Service Bulletin

Crew Seat Inspection.

Document: Service Bulletin SB-GA8-2003-09

Figure 1. Seat positioned for inspection

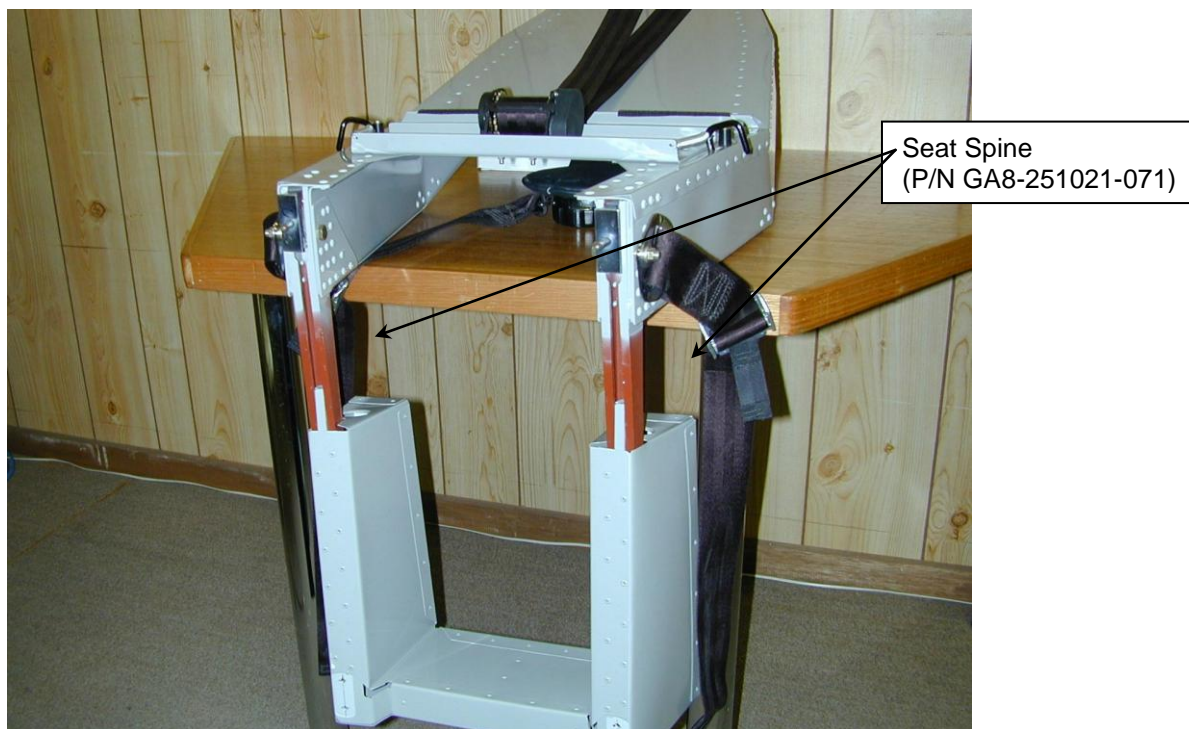
1. Remove the crew seat travel stops and then the crew seats from the aircraft.
2. Unscrew the forward seat feet (P/N GA8-251021-075) and slide the seat base (P/N GA8-251011-025) forward as far as possible. The base should move forward about 4 inches and the steel spines (P/N GA8-251021-071) will be visible, see figure 1. It is only necessary to inspect for notches in the aft visible portion of the spine.

3. Inspect the spines for drill spots. Any circular spots less than 0.135" diameter may be left as is, however, drill spots deep enough to have parallel edges are not allowed. Any marks impacting the edge of the spine, producing an effective chamfer up to a maximum dimension of 0.050" by 0.050", must be carefully blended out. Extensions of the edge marks, caused by the drill sliding off the edge, which are less than 0.010" deep are allowed.

When blending out the marks care must be taken not to reduce the cross sectional area any further and the blending should extend 10 times the mark depth either side of the mark.

4. If drill spots greater than 0.135" diameter, drill spots deep enough to have parallel edges or edge marks with a maximum dimension greater than 0.050" are found, contact Gippsland Aeronautics.
5. If the circular marks are less than 0.135" diameter or any edge marks have a maximum dimension less than 0.050", renew the corrosion protection, reassemble the seat in the reverse order of disassembly and return the seat to service. Ensure seat stops are reinstalled and perform a function check on the seat pins.
6. Enter compliance with this service bulletin in the aircraft log books.
7. In all cases where the inspector has any doubts or concerns over the inspection method or results Gippsland Aeronautics may be contacted to provide technical support.
